Origination Form
Proposed Revisions to a Standard Plans Index

Originator:	Turley, Joshua	Index Number:	400-090
Date:	5/15/2025	Sheet Number(s):	Sheet 2
E-mail:	Joshua.Turley@dot.state.fl.us	Index Title:	APPROACH SLABS (30 FT.) (FLEXIBLE PAVEMENT APPROACHES)

APPROACH SLAB WITH RETAINING WALL DETAILS

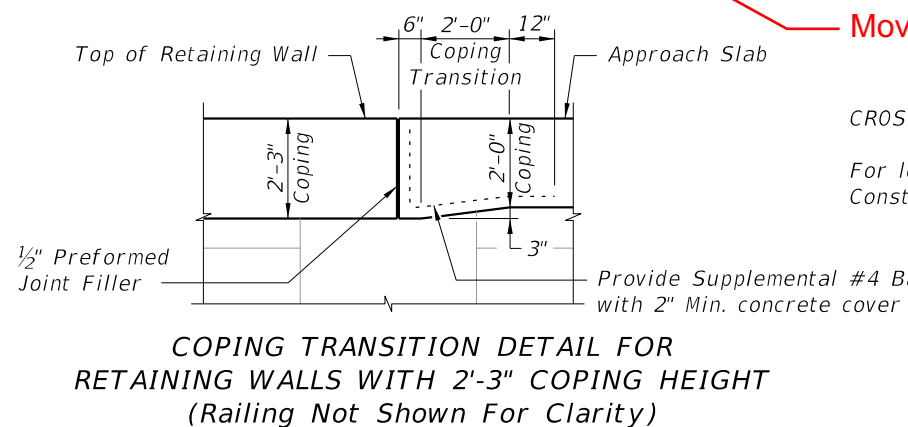
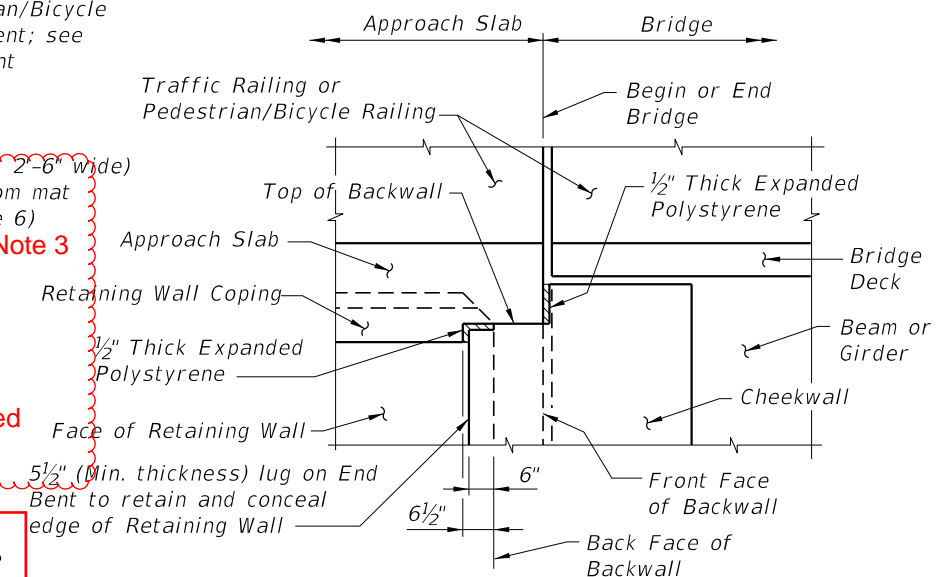
Sheet 2: Converted starred notes to numerical notes; Adjusted the coping embed requirements for the top of the retaining wall in SECTION THRU APPROACH SLAB AND RETAINING WALL.

Contractors had trouble meeting top-of-wall elevations for MSE walls due to settlement issues. When predicted settlement didn't occur, walls were too high and required sawcutting. To address this, minimum thickness and embedment requirements for Expanded Polystyrene were relaxed, allowing better control over final wall elevations.

Moved to NEW Note 2

- 1.
- 2.
3. Expanded Polystyrene 1" min. top for MSE walls, 3" min. top for rigid retaining walls. 1/2" each side.
